**METROPOLITAN GOVERNMENT OF NASHVILLE AND DAVIDSON COUNTY**

**STAFF RECOMMENDATION**  
**1328 3<sup>rd</sup> Avenue North**  
**January 16, 2019**

**Application:** New Construction—Infill  
**District:** Germantown Historic Preservation Zoning Overlay  
**Council District:** 19  
**Map and Parcel Number:** 08209020700  
**Applicant:** Brian Haun, Allard Ward Architects  
**Project Lead:** Melissa Baldock, melissa.baldock@nashville.gov

**Description of Project:** Application is to construct a plex house infill in the East Development Zone of the Germantown Historic Preservation Zoning Overlay.

# Roof Plan

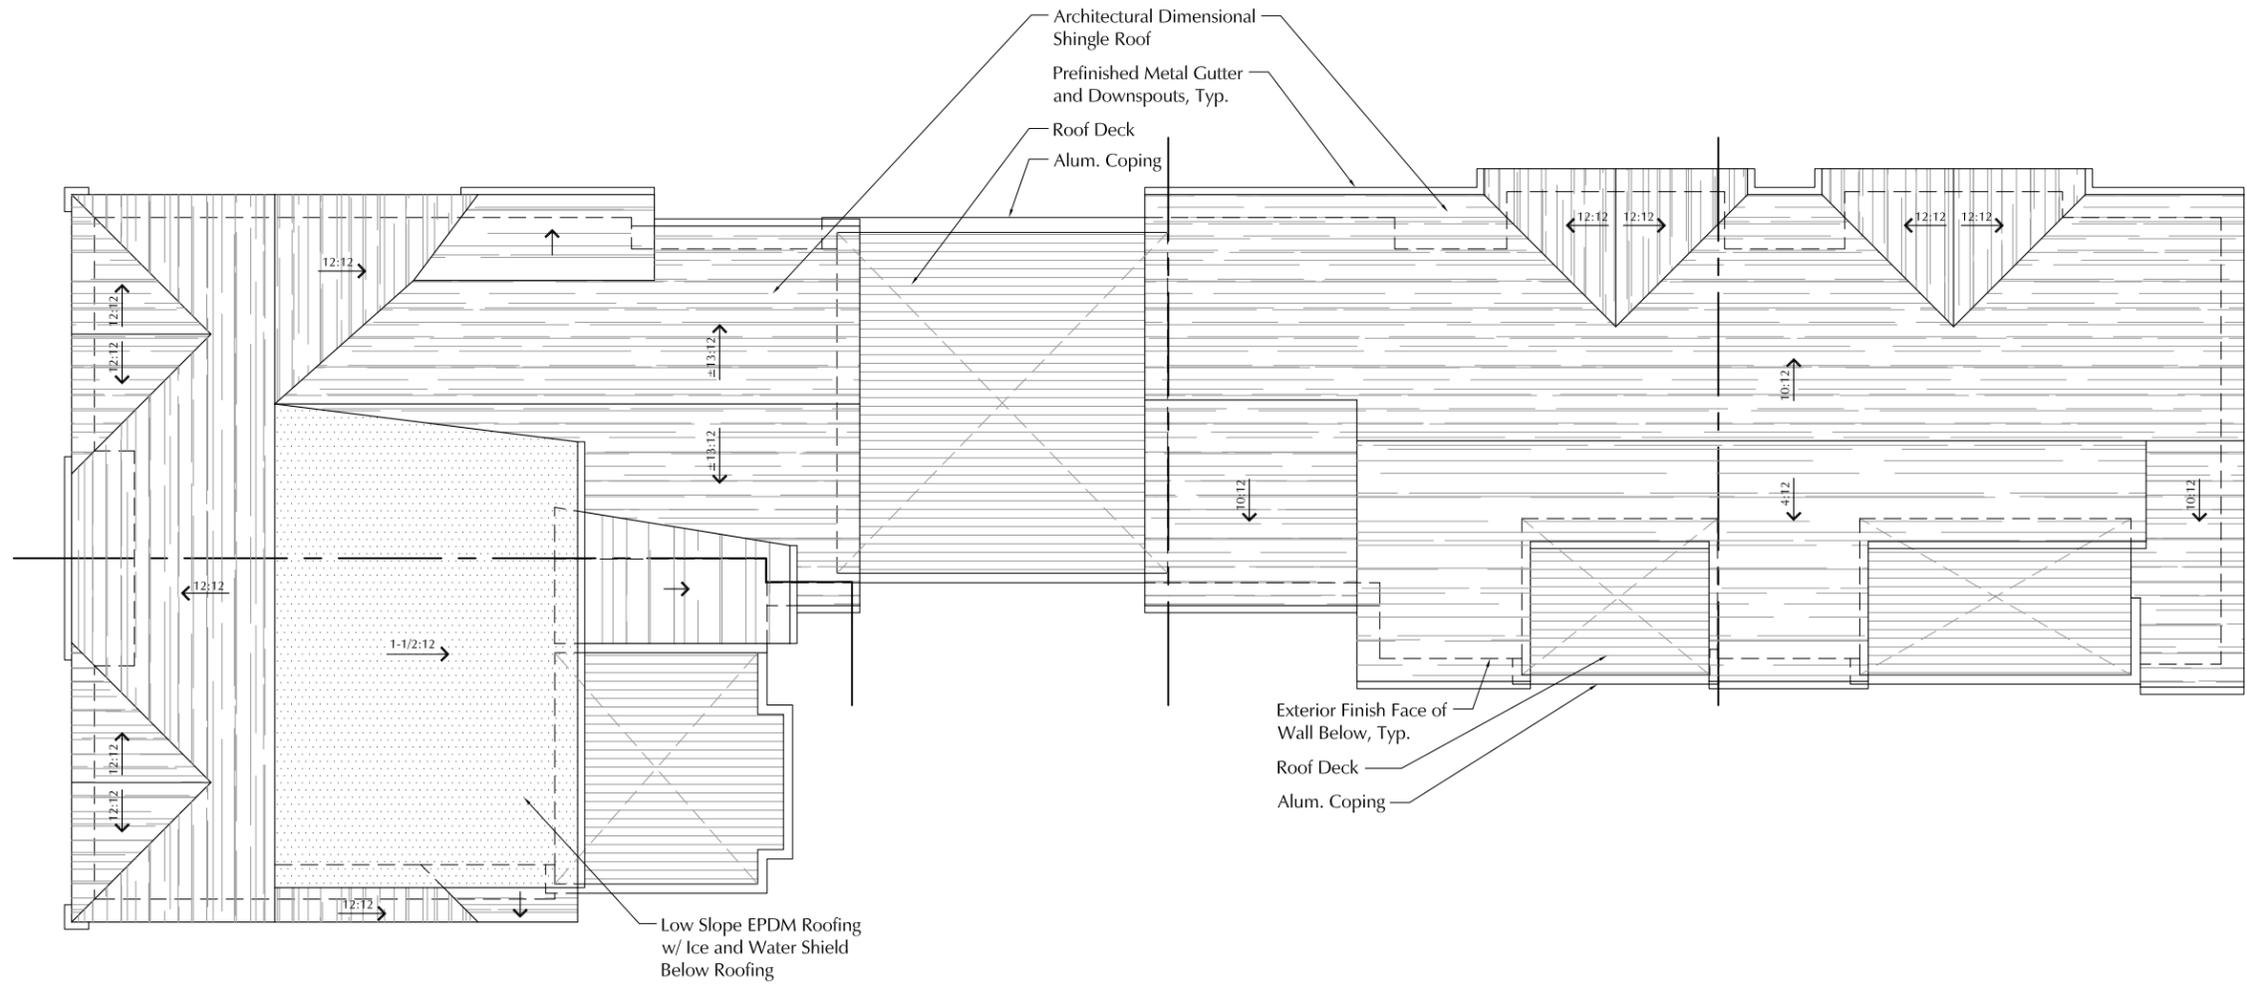
Rooftop Decks: The residential units have rooftop decks, which can be appropriate in this development zone. Three of the four rooftop decks are located on the interior court of the structure, and will not be visible from the street. There is a rooftop deck facing Taylor Street that extends up to the edge of the building. The design guidelines state that rooftop decks “should sit back a minimum of 5’ from the side street-facing wall in the case of corner buildings.” Staff therefore recommends that this rooftop deck be setback five feet (5’) from the edge of the 3<sup>rd</sup> Avenue North wall. With this condition, staff finds that the proposed roof decks meet Section III.E.9. of the design guidelines.

Utilities/Mechanicals: The location of the HVAC units was not indicated on the plans. Staff recommends that they be located on the interior of the development, or on the roof, not visible from the street.

1. The finished floor height be consistent with the finished floor heights of the neighboring historic houses, to be verified by MHZC staff in the field;
2. The rooftop deck facing Taylor Street be setback five feet (5’) from the Taylor Street wall;
3. Staff approve the final details, dimensions and materials of windows and doors prior to purchase and installation;
4. Staff approve all brick and paver samples;
5. Staff approve the roof shingle color and texture;
6. Staff approve the material of the stoop steps and landings; and
7. The HVAC units and other utilities be located on the interior court, or on the roof.
